Public Service Company of Colorado

January 21, 1981
Fort St. Vrain
Unit No. 1
P-81021

Subject: Supplementary Information
for Proposed Change to
Technical Specification
Table 6.1-1

Figure 18 Calculated Base
Reactivity

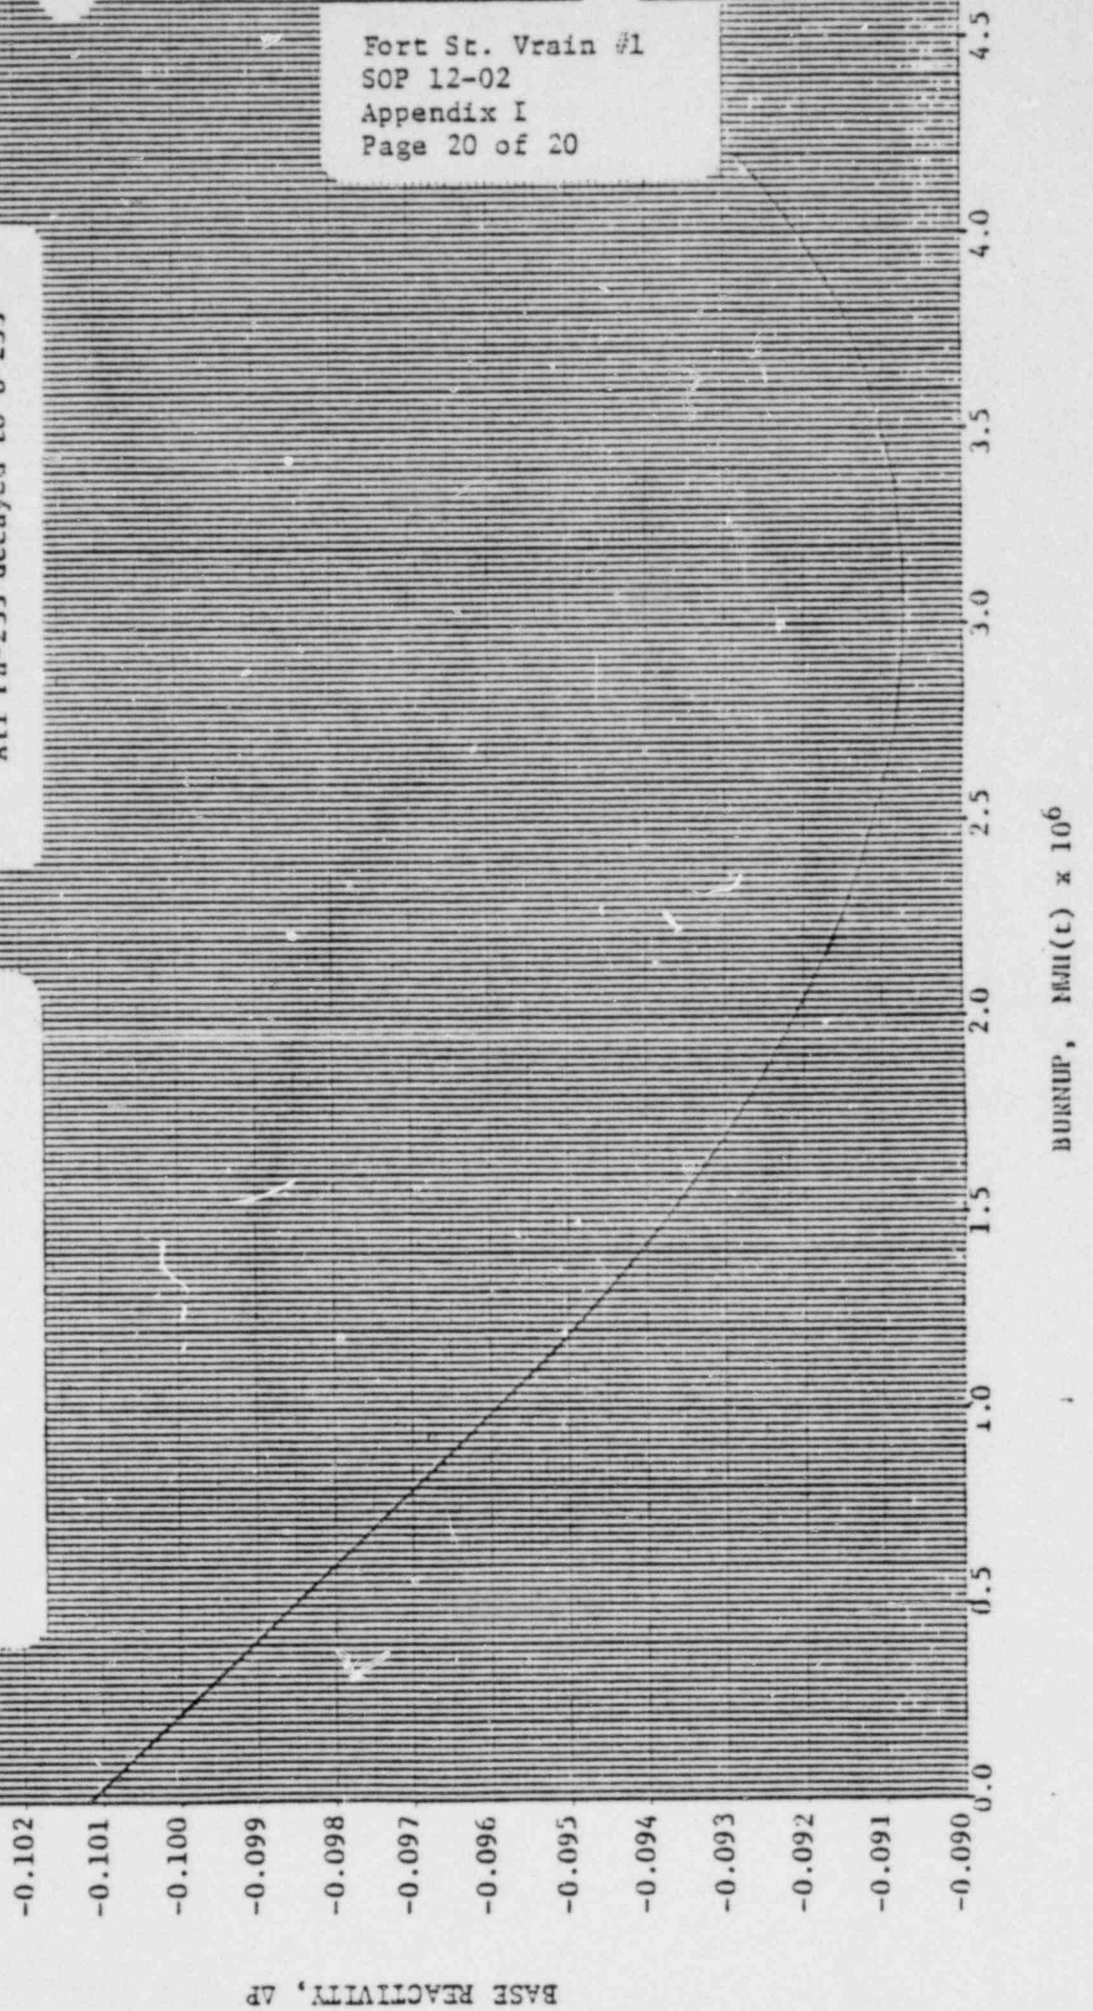
In accordance with the requirements of Technical Specification LCO 4.1.3, we have attached an approved revised Base Reactivity Curve for your information. It should be noted that the only change to the curve has been to extend it from 3.0×10^6 MWhr to 4.2×10^6 MWhr to account for the extended operation of Cycle 1 (4.05×10^6 MWhr is the equivalent of 200 EFPD).
